Access Compliance Report

Public Rights-of-Way

(Curb Ramps)

Intersection ID: 10770	Main Street: ALICE_AV	Cross Street: TUCKASEEGEE_RD	Location:	E
ADA ID: 38CB48673AA7	Ramp Type: Directional1	Initial Pass/Fail: Fail	Overall Compliance: No	Severity Score: 25
Codes/Mitigation Info/Possible Solution		Field Measurements/Component Compliance

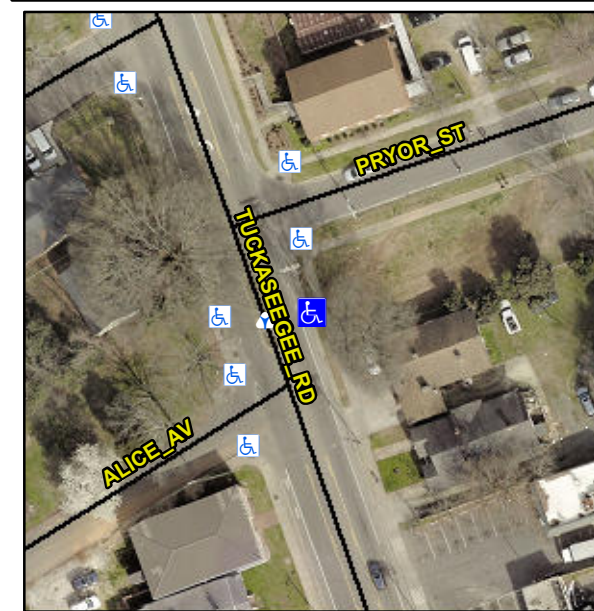
R304.2.2

Compliance	Description	Data	Compliance	Description	Data
N/A	Ramp Length (in)	49.0	N/A	Grade Break?	N/A
Yes	Ramp Width (in)	50.5	N/A	Grade Break Slope (%)	0.0
No	Ramp Slope (%)	17.6	N/A	Grade Break XSlope (%)	0.0
Yes	Ramp XSlope (%)	1.3			
N/A	Flare Type LT	N/A	N/A	Flare Type RT	N/A
N/A	Flare Slope LT (%)	N/A	N/A	Flare Slope RT (%)	0.0
N/A	Flare Traversable LT?	N/A	N/A	Flare Traversable RT?	N/A
N/A	Landing Length (in)	0.0	N/A	DWS Provided?	N/A
N/A	Landing Width (in)	0.0	N/A	DWS Contrast?	N/A
N/A	Landing Slope (%)	0.0	N/A	DWS Length (in)	N/A
N/A	Landing X Slope (%)	0.0	N/A	DWS Full Width?	N/A
N/A	Landing Curb? (Y/N)	N/A	N/A	DWS Offset LT (in)	N/A
N/A	Shared Landing?	N/A	N/A	DWS Offset RT (in)	N/A
N/A	Gutter Ponding?	0.0	N/A	Gutter Slope (%)	N/A
N/A	Gutter Lip Ht (in)	0.0	N/A	Gutter X Slope (%)	N/A
N/A	Painted X Walk1?	No		Road Slope (%)	5.9
	X Walk 1 Direction	To W		Road X Slope (%)	0.6
	X Walk 1 Width (in)	N/A		Clear Space?	N/A

Remove & Replace Entire Ramp.
